GENERAL T.I. BULLETIN INDEX

Number	Gn001
(JCB Gen 003)	
Issue	1
Date	March 1990

SUBJECT: Tappet Adjustment

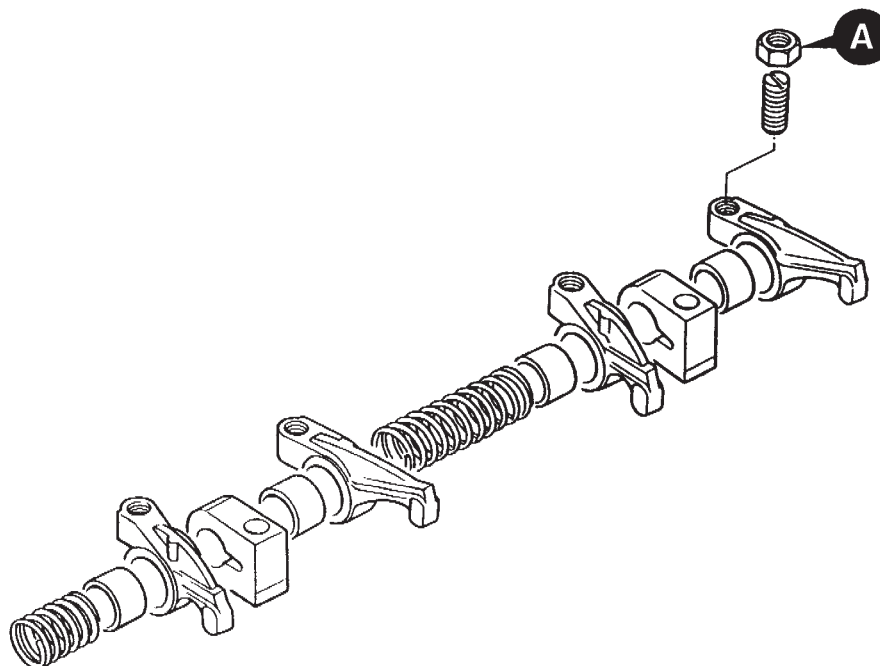
When tappet adjustment is required, it is important to re-torque the adjusting screw lock nut **A**. If this is not correctly actioned the adjusting screw will become loose which could cause damage to the tappet assembly and push rod.

Lock Nut Torque - 20 lbs ft.

SUBJECT: Rocker Shaft Security

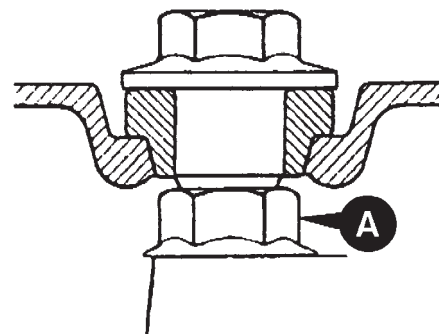
Flanged nuts **A** replace the three nuts and washers securing the rocker shaft to the cylinder head. The single bolt and washer is replaced by a flanged bolt.

If the new fasteners are fitted to earlier engines the washers must be removed.

Torque tighten the new fasteners to 40 Nm (30 lbf ft).

02/291060	NUT	replaces	1370/0401Z
02/291048	SET SCREW	replaces	02/291125
02/291064	WASHER	-	Not Required

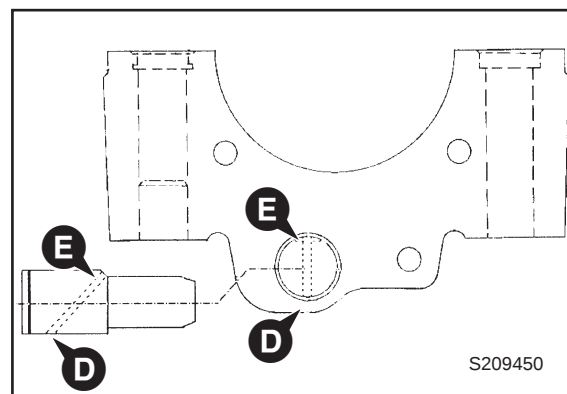
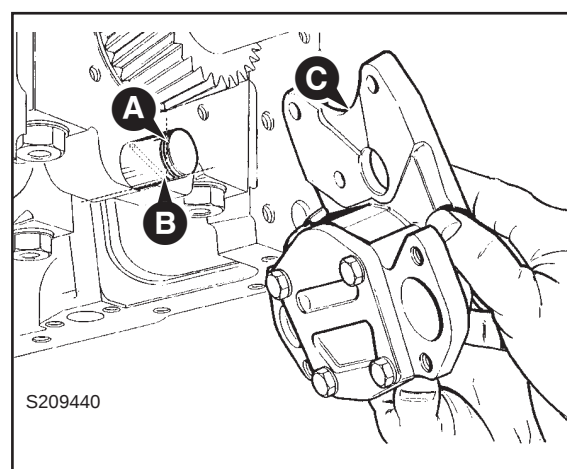
A new idler shaft **A** has been introduced which has an oil hole **B** to provide more lubrication to the bush for the idler gear. Also a new lubricating oil pump has been introduced which has a channel **C** in the body of the pump. Lubricating oil from the front main bearing passes down the channel in the body of the pump to the oil hole in the idler shaft. The lubricating oil then passes through the hole in the idler shaft to the bush in the idler gear.

Note: The above information can be implemented only when excessive wear is evident.

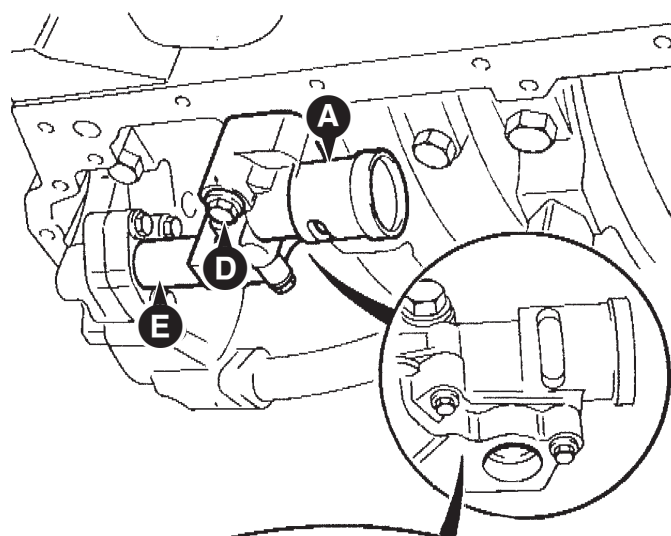
The possibility exists that engine relief valve housing **A** may fail. The relief valve controls the engine lubricating system oil pressure, therefore a failure of the housing could result in the loss of engine oil pressure and cause subsequent damage to the engine.

Investigation has shown that the relief valve housing has been machined incorrectly and remedial procedures have already been implemented to ensure all relief valve housings are now machined to the correct specification.

- 5** Provide a support for the sump and remove the sump retaining bolts. Lower the sump and remove the sealing gasket.
- 6** Inspect the relief valve housing:
- 6.1** Look at the side of the relief valve housing **A** for the manufacturer's number.
- 6.2** If the number has a '1' below it as shown at **B**, then the housing is made to the correct specification, move to step **9**.
- 6.3** If the number has a '2' below it as shown at **C**, then the housing is made to the wrong specification and must be replaced with a new one, move to step **7**.

- 7** Remove the relief valve housing retaining bolt **D**, and then remove the relief valve housing **A**.
- 8** Fit a new replacement relief valve housing, torque tighten the retaining bolt to 22 Nm (16 lbf ft). Make sure that the 'O' ring at each end of tube **E** are in good condition and securely in place before tightening the retaining bolt.
- 9** Refit the engine sump together with a new gasket. Tighten the sump retaining bolts to 22 Nm (16 lbf ft). Fit the sump drain plug together with a new 'O' ring, torque tighten the plug to 34 Nm (25 lbf ft). Refit the dipstick and dipstick tube.
- 10** Using the engine oil drained at step **3** refill the engine sump, make sure that the engine oil reaches the 'MAX' mark on the dipstick, top up as required.

SUBJECT: Change of position for the exhaust manifold alignment bushes

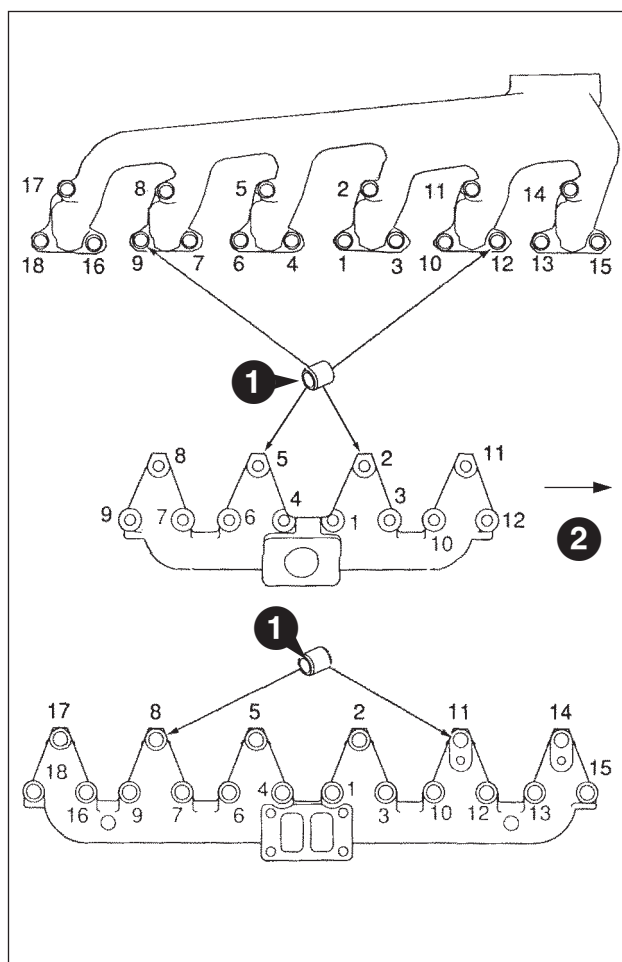
Caution: Damage to the exhaust manifold can occur if it is not aligned and tightened correctly.

If the manifold is renewed, it is important that the two alignment bushes (1), JCB part number 02/201783 are in position. New alignment bushes are not necessary when the original manifold is removed and fitted.

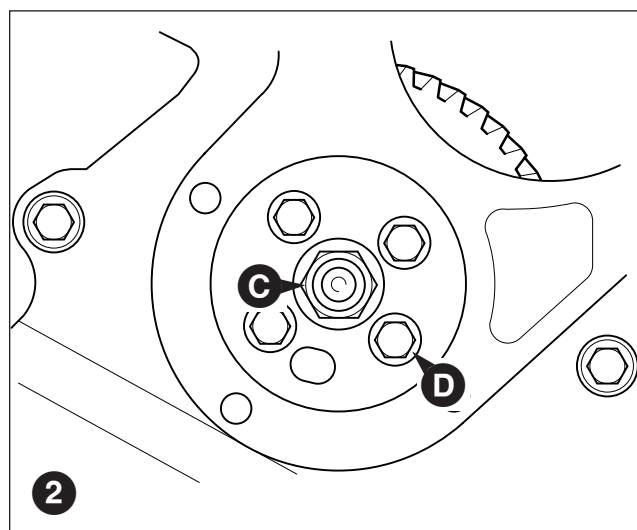
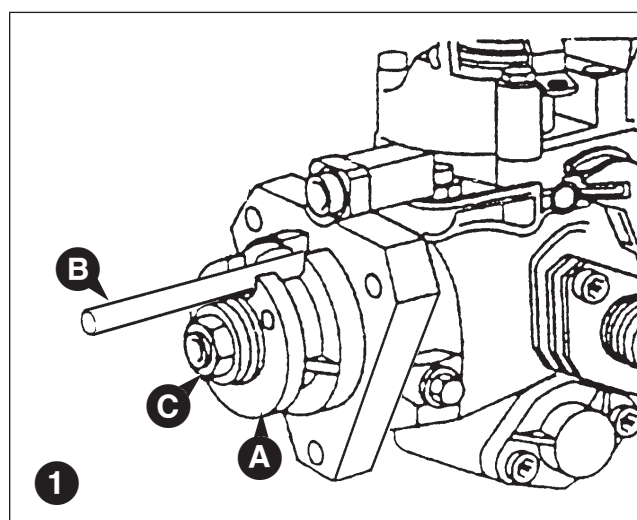
The latest fuel injection pumps have a hub **A** which is **mounted permanently** onto the drive shaft.

Caution: Do not release the nut **C** from the fuel injection pump. Illustration 2 shows the nut **C** in position when the fuel pump is fitted to the engine. The fuel pump hub is fitted to the shaft in the factory to ensure that the fuel pump is in the correct position for timing. If the nut is removed and the hub moves, the hub will need to be accurately fitted to the pump by use of specialist equipment before the pump can be fitted to the engine.

To remove the fuel injection pump from the engine it is only necessary to remove the four setscrews **D** which secure the fuel pump gear to the hub. It is important to follow the instructions in the workshop manual to ensure the engine timing is correct.

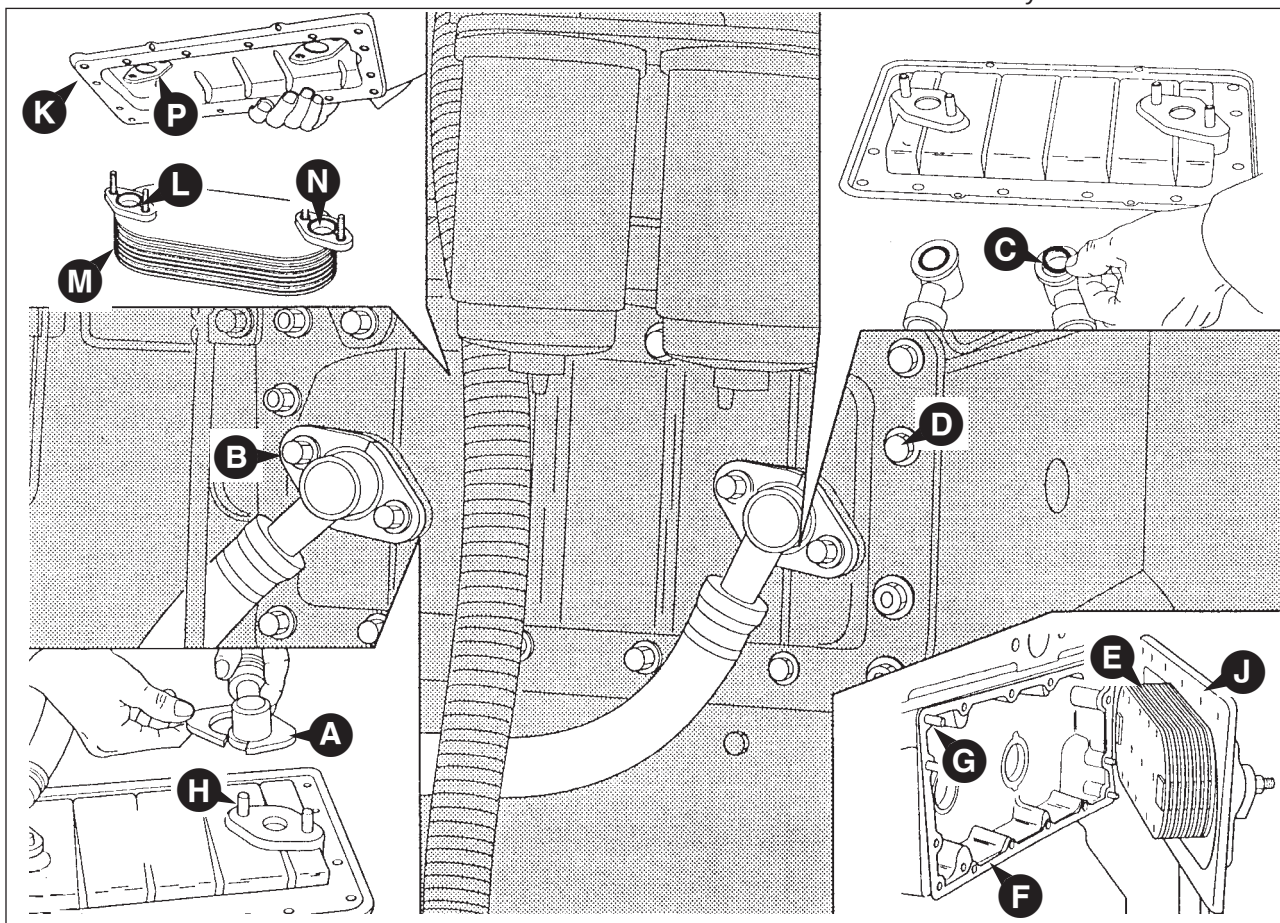
An improved oil cooler with a pressed steel cover has been introduced with effect from engine serial number YB-----U647452C.

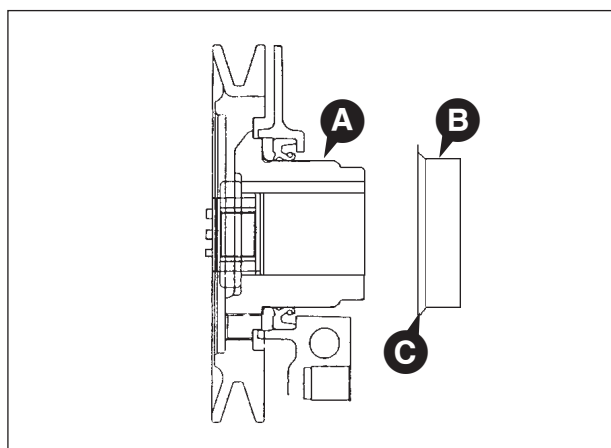
Caution: If the lip of the oil seal has worn a groove in the spigot **A** of the crankshaft pulley, oil will continue to leak after the new oil seal is fitted.

To renew a worn crankshaft pulley, for engines with the latest timing case, a wear sleeve **B** part number 02/202027 is fitted over the spigot.

The dimension to press the new oil seal into the timing case, with or without a wear sleeve fitted, is 9.3 mm (0.366 in), from the front face of the timing case. The special tool supplied in the kit can be used to set the correct depth.

Washers for the Fuel Injection Pump Gear

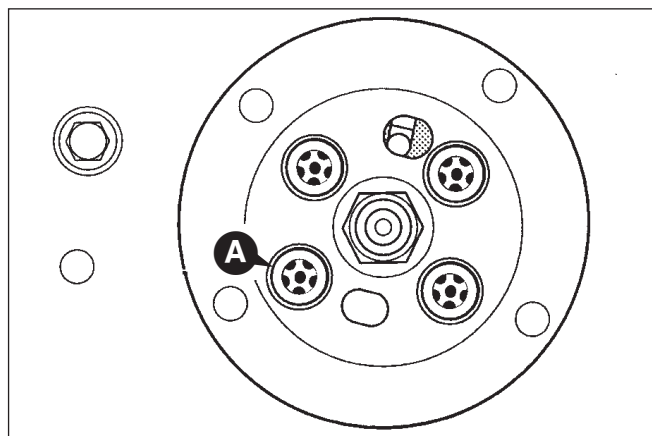
A washer, part number 02/101686, is fitted to each of the screws **A** with effect from the following engine serial numbers:

Caution: Ensure that the washers are fitted before the screws are tightened.

Improved Exhaust Valve Guide

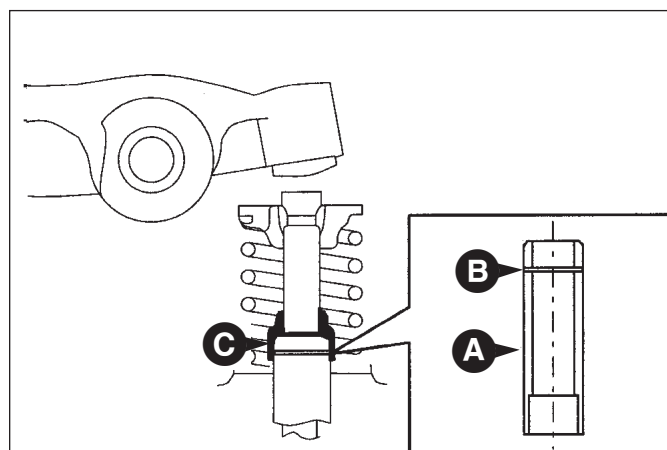
An improved exhaust valve guide **A** has been introduced. The new guide has a groove **B** to retain the valve seal **C**.
